SUBJECT: Grand Gulf Nuclear Station
Unit 1
Docket No. 50-416
License No. NPF-29
Improved Technical Specification
Development Program
AECM-90/0102

ATTACHMENT TO AECM-90/0102

TECHNICAL SPECIFICATIONS IMPROVEMENT PROGRAM

CHAPTERS 3.1, 3.9, AND 3.10

Figure 3.1.8-1 (Page 1 of 1)

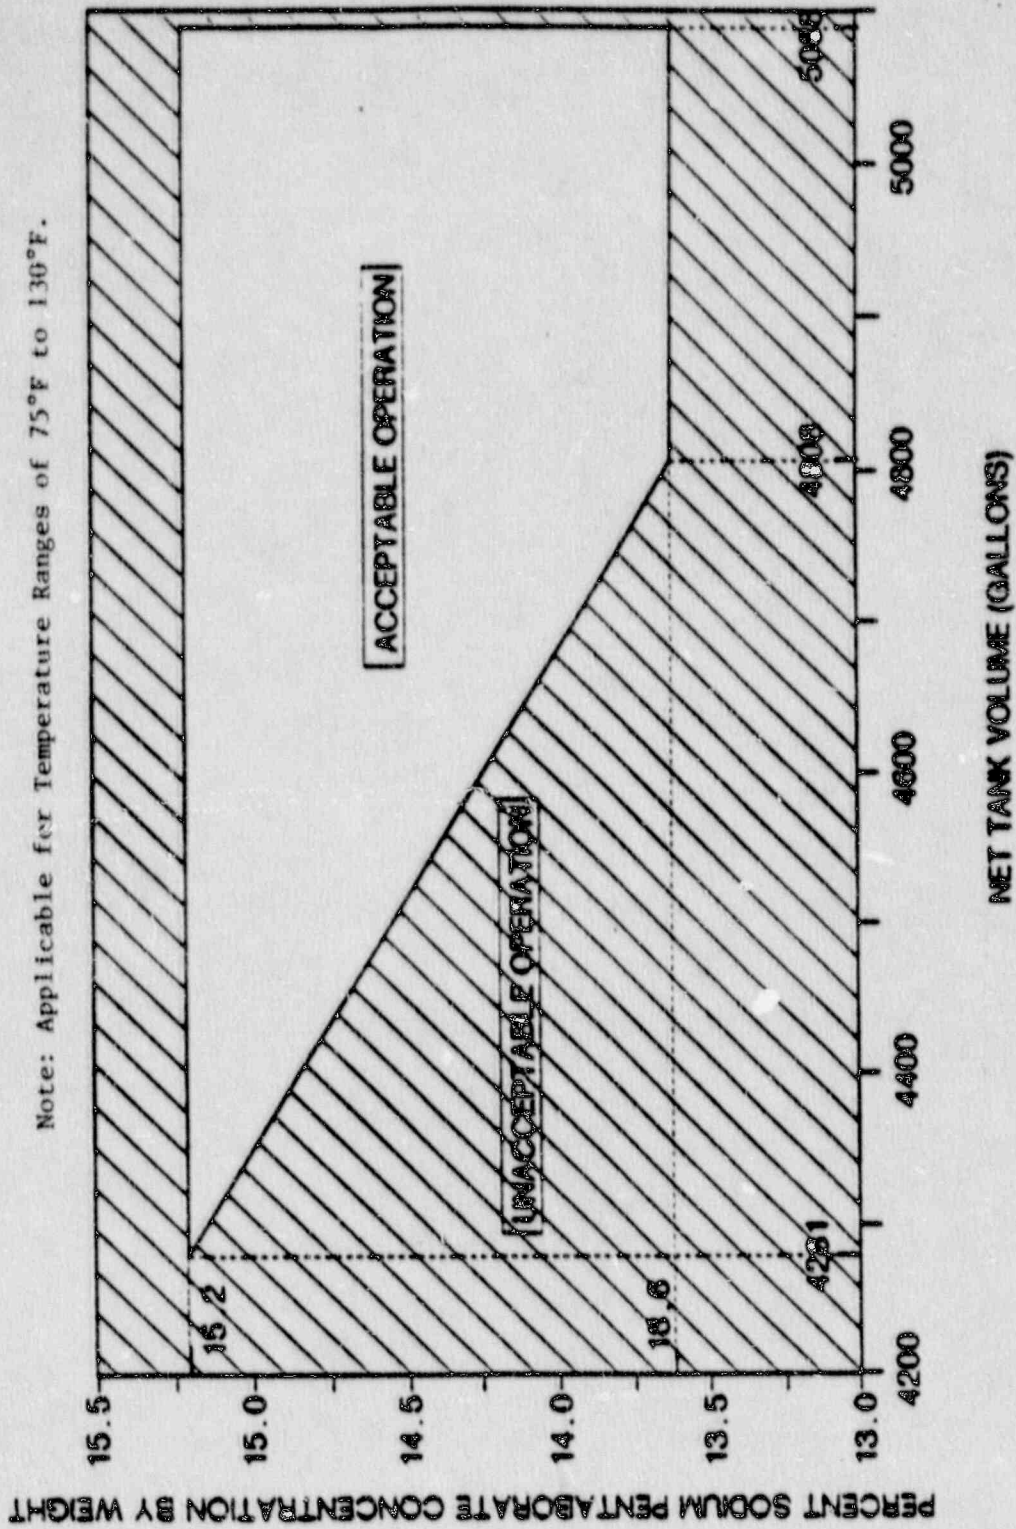
SURVEILLANCE		FREQUENCY
SR 3.1.8.1	Verify available volume of sodium pentaborate solution is within the limits of Figure 3.1.8-1.	24 hours
SR 3.1.8.2	Verify temperature of sodium pentaborate solution is $\geq 75^{\circ}\text{F}$ and $\leq 130^{\circ}\text{F}$	24 hours
SR 3.1.8.3	Verify temperature of pump suction piping is $\geq 75^{\circ}\text{F}$ and $\leq 130^{\circ}\text{F}$.	24 hours
SR 3.1.8.4	Verify continuity of explosive charge.	31 days
SR 3.1.8.5	Demonstrate by chemical analysis the concentration of boron in solution is within the limits of Figure 3.1.8-1.	31 days <u>AND</u> Once within 24 hours after water or boron added to solution <u>AND</u> Once within 24 hours after solution temperature is restored $\geq 75^{\circ}\text{F}$.
